Addendum to Appendix A – WDT780

Queue Cluster 4 Phase I Report

March 27, 2012

Figure 2-2, Proposed Single Line Diagram (Revised)

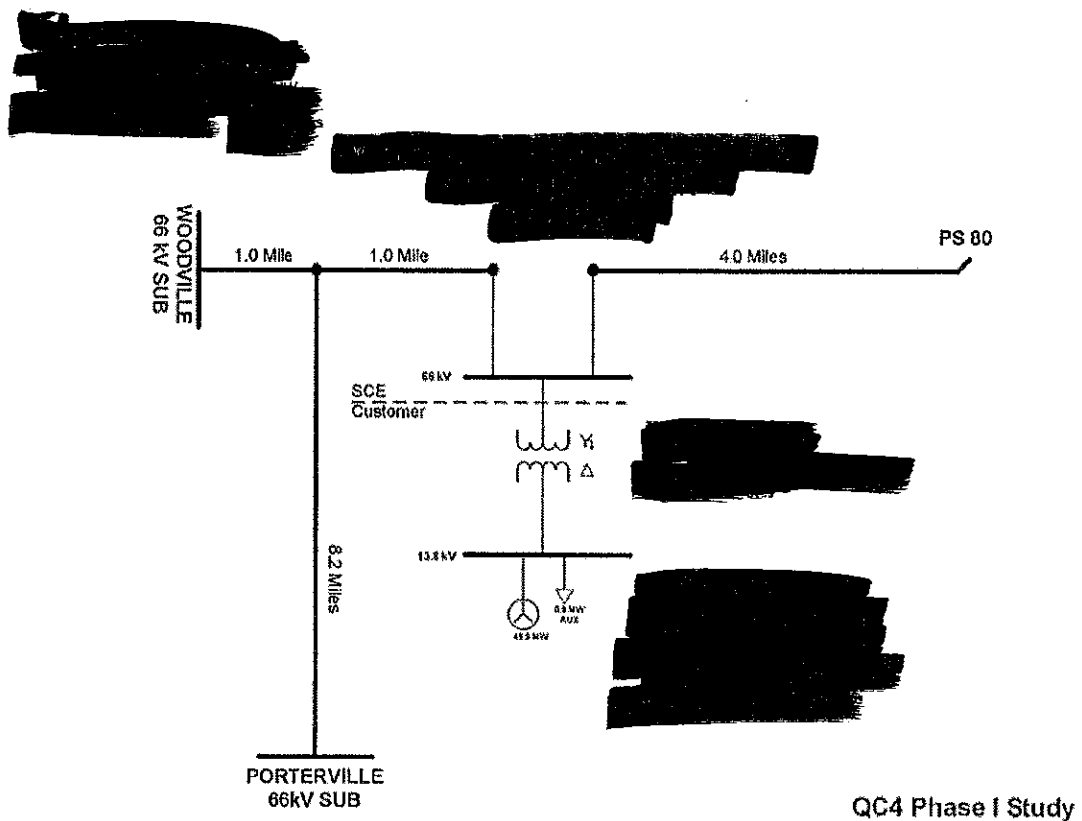
During the Results Meeting with the IC on [REDACTED], the IC requested that the report be revised to reflect the interconnection substation as a looped-in substation as opposed to a tapped substation, assumed in the original Phase I Appendix A Report.

1. Revise Figure 2-2, Proposed Single Line Diagram (page 5) in Section 2, plus revise selected text in Sections 3 and 10, (pages 6, 12 and 13), in the original Phase I Appendix A report, to reflect a looped-in interconnection substation.
- **Section 2. Project and Interconnection Information**, Figure 2-2, Proposed Single Line Diagram (page 5), replace the proposed Single Line Diagram with the following Diagram:

- **Section 3. Study Assumptions**, paragraph C, (page 6), revise the Phase I study report as follows:
Replace all “tapped substation” terms in the original Appendix A Report with the term “looped-in substation.”
